5.3 NO. 242 (LOT: 2; D/P: 1641) LAKE STREET, PERTH - PROPOSED ALTERATIONS AND ADDITIONS TO A SINGLE HOUSE AND SHOP

To consider an application for development approval for alterations and additions to an existing shop and single house at No. 242 Lake Street, Perth (the subject site).

Mid level floor Plan scale 1 : 100

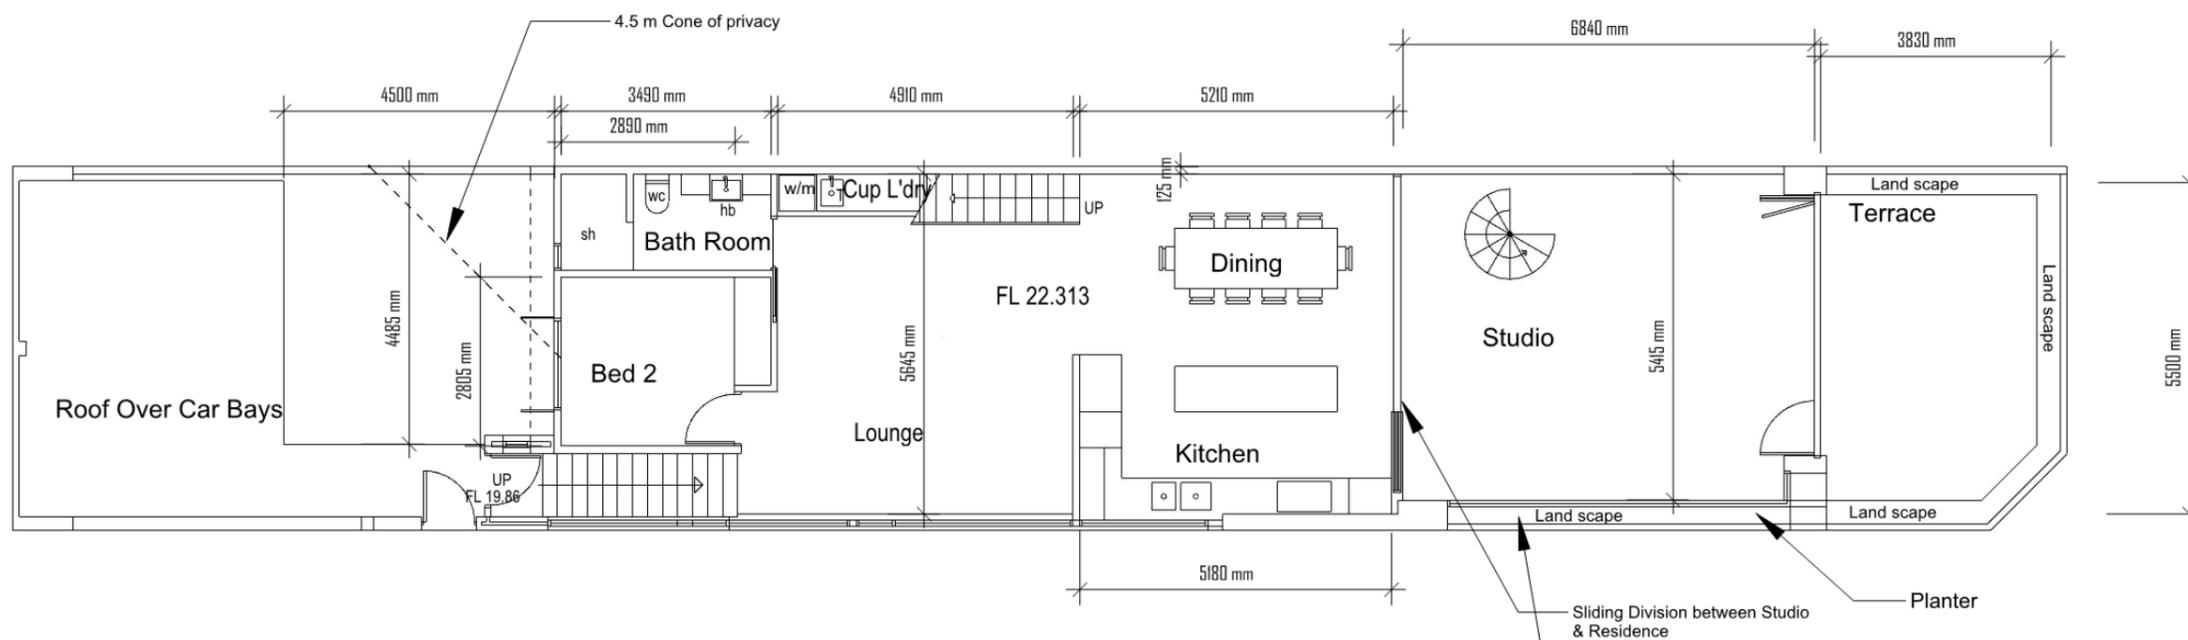
- a) The mid level bedroom 2 window shroud shall be extended to ensure that a 4.5 metre cone of vision setback is provided from this window to the south eastern lot boundary, in accordance with the deemed-to-comply standards of the Residential Design Codes Volume 1, Clause 5.4.1 (Visual Privacy), to the satisfaction of the City; and
- b) The height of the solid balustrading along the south eastern side of the upper floor roof deck shall be increased from 1 metre to 1.6 metres above the finished floor level of the roof deck, in accordance with the deemed-to-comply standards of the Residential Design Codes Volume 1, Clause 5.4.1 (Visual Privacy), to the satisfaction of the City.

The R Codes deemed-to-comply standards relating to visual privacy outline that the mid level bedroom 2 window should provide a 4.5 metre cone of vision setback to the south eastern lot boundary and the application proposes a 4.4 metre setback.

The proposed plans show a 4.5 metre cone of vision to the south eastern lot boundary from the mid level bedroom 2 window. Administration has identified that this setback measures to 4.4 metres rather than 4.5 metres.

- Modify the mid level bedroom 2 window vertical screens to provide a 4.5 metre cone of vision setback to the south eastern lot boundary in order to satisfy the deemed-to-comply standards of the R Codes; and
- Increase the height of the solid balustrading along the south eastern side of the upper floor roof deck from 1 metre to 1.6 metres to mitigate direct overlooking to the adjoining property to the south.
